**CITY OF LEWISTON  
PLANNING BOARD MEETING**  
Monday, April 27, 2020 – 5:30 P.M.  
Lewiston City Government  
27 Pine Street, Lewiston, ME

RE: Agenda Item 4a. Development Review and Traffic Movement Permit Request for Dunkin Donut shop and Multi-tenant Building at 1896 Lisbon Street

Re: Dunkin Donuts  
1896 Lisbon Street  
Response to Staff Comments

**Landscape Plan**  
1896 Lisbon Street  
Lewiston, ME 04240  
Prepared for:  
**Connor Realty, LLC**  
1124 Lisbon Street - Lewiston, ME 04240

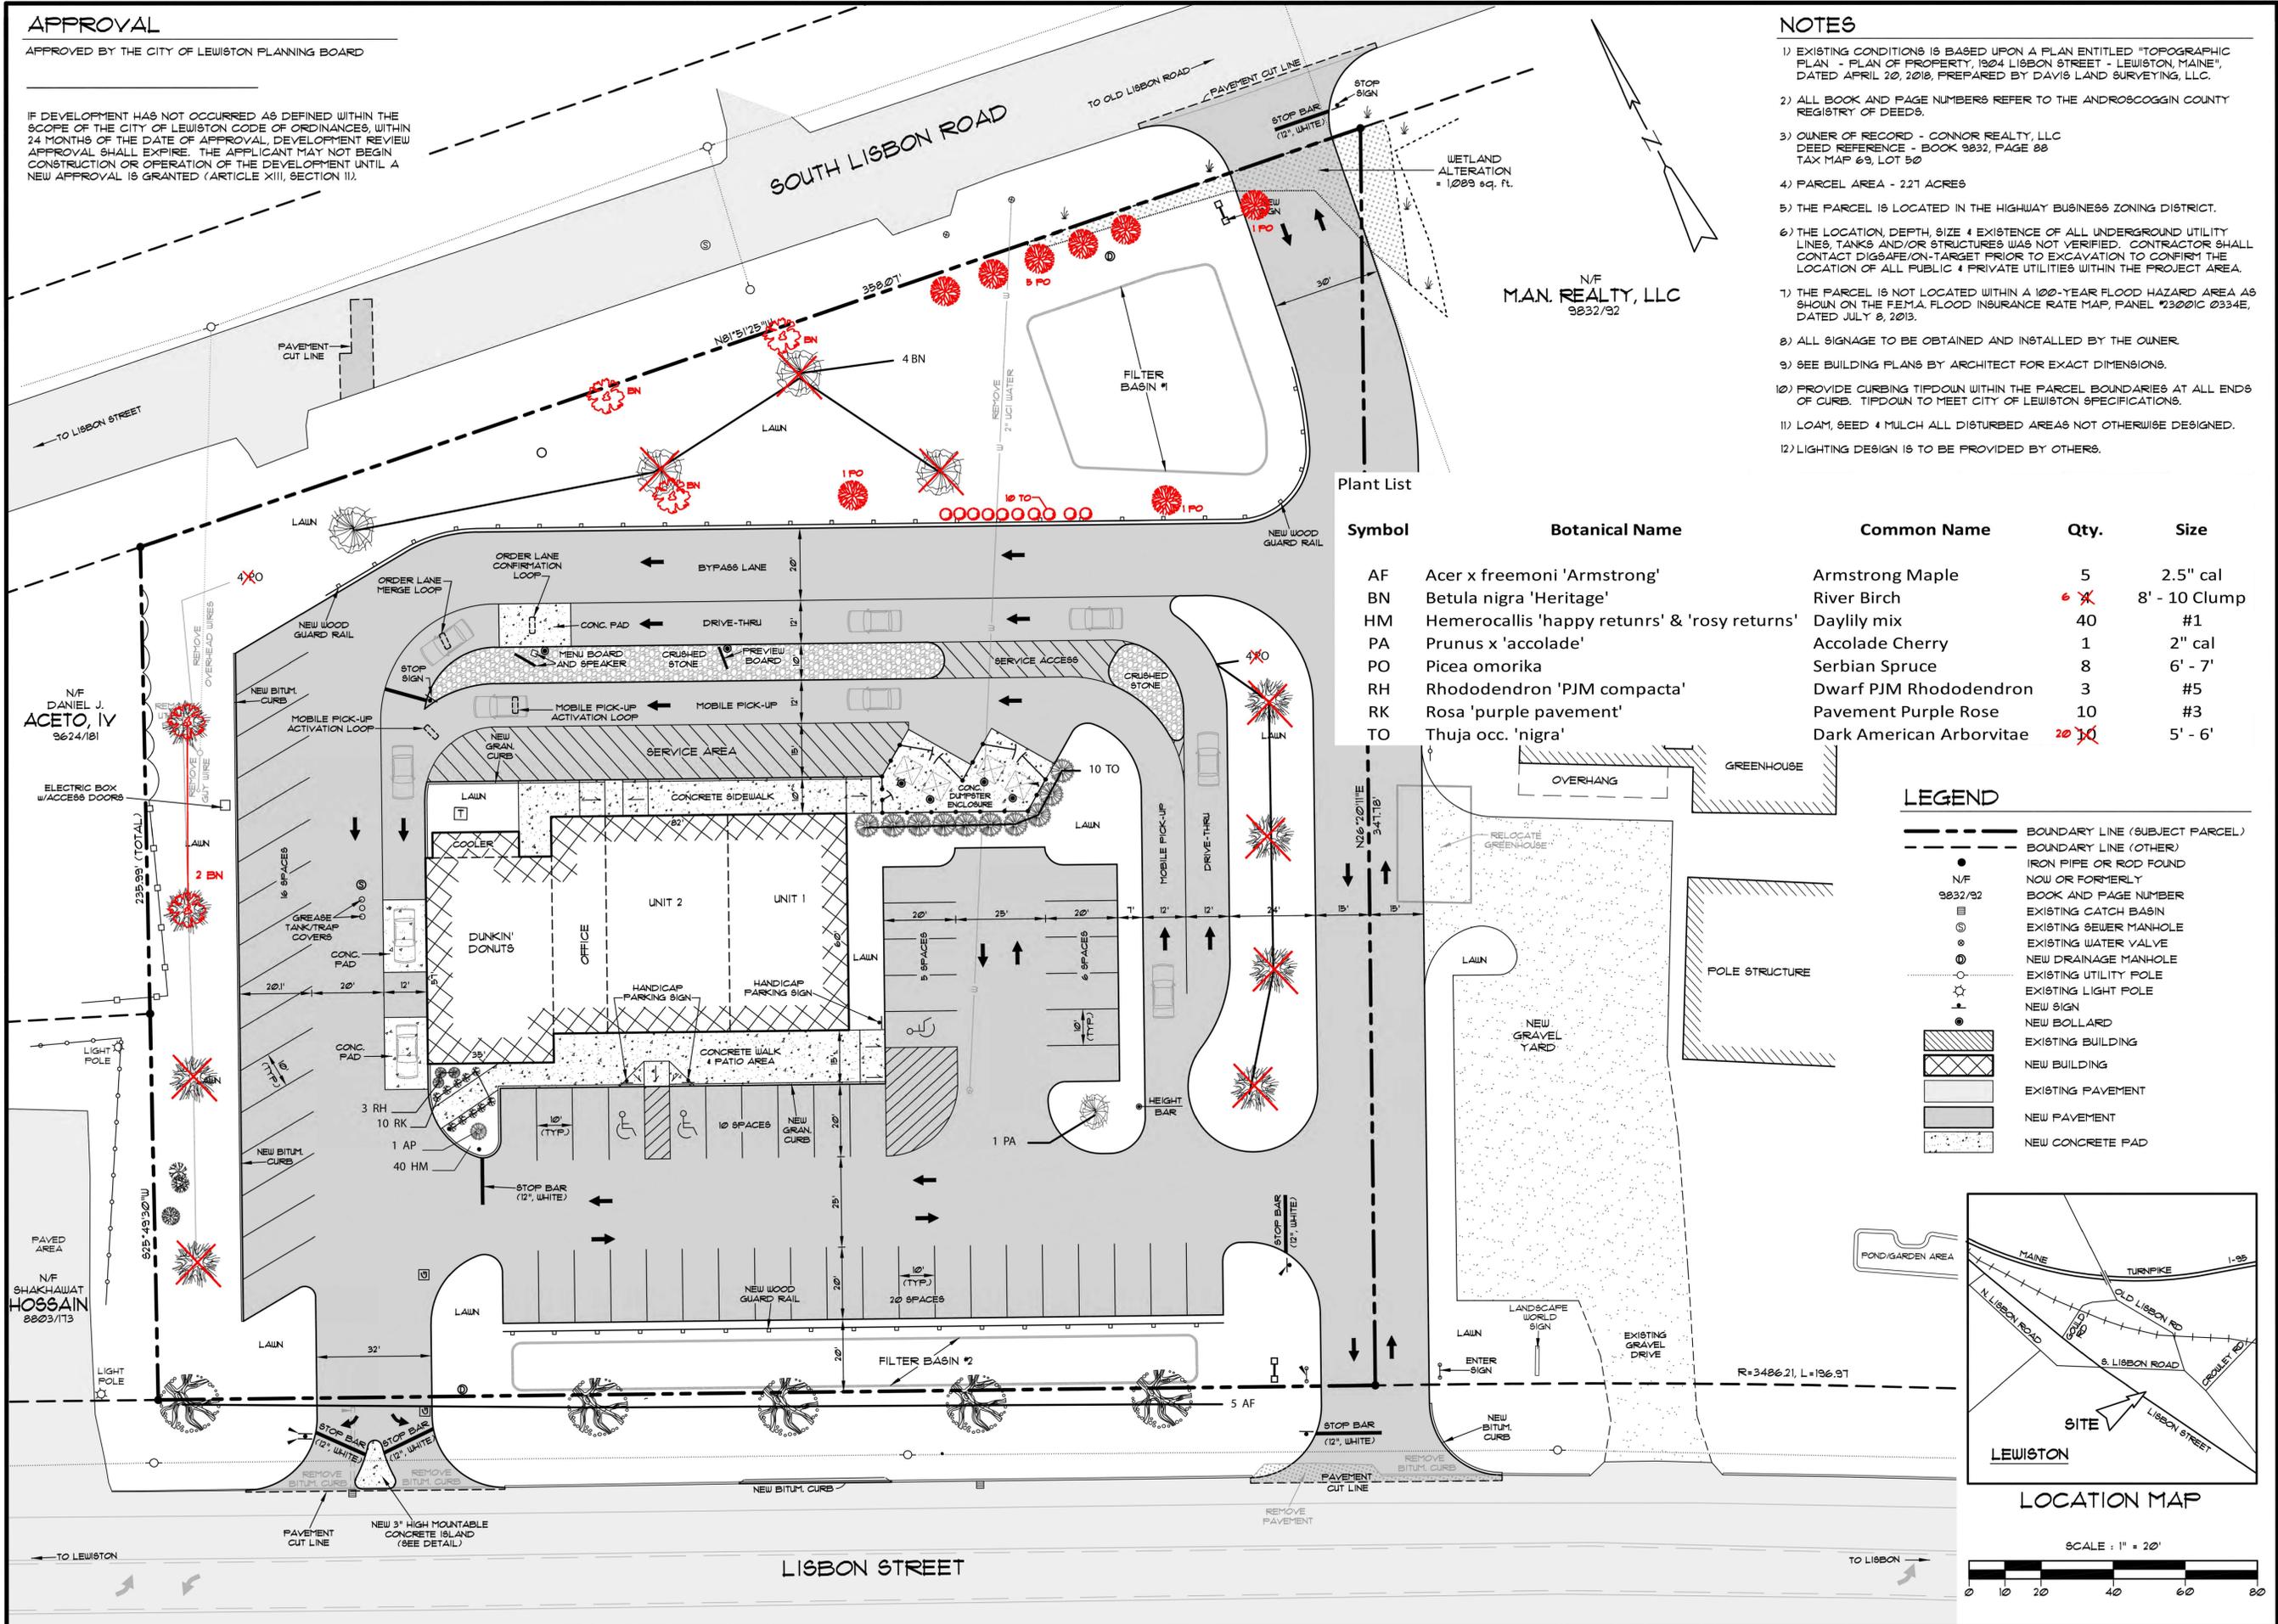
1. The initial application submission did not include a landscape plan. A landscape plan has since been submitted. Staff is satisfied with the landscape plan, which includes street trees, shrubs and planting beds. The applicant desires to build and open the Dunkin Donuts before the end of this year and is asking to complete the installation of the planting plan prior to the issuance of final certificate of occupancy. (Note 13 on Site Plan)
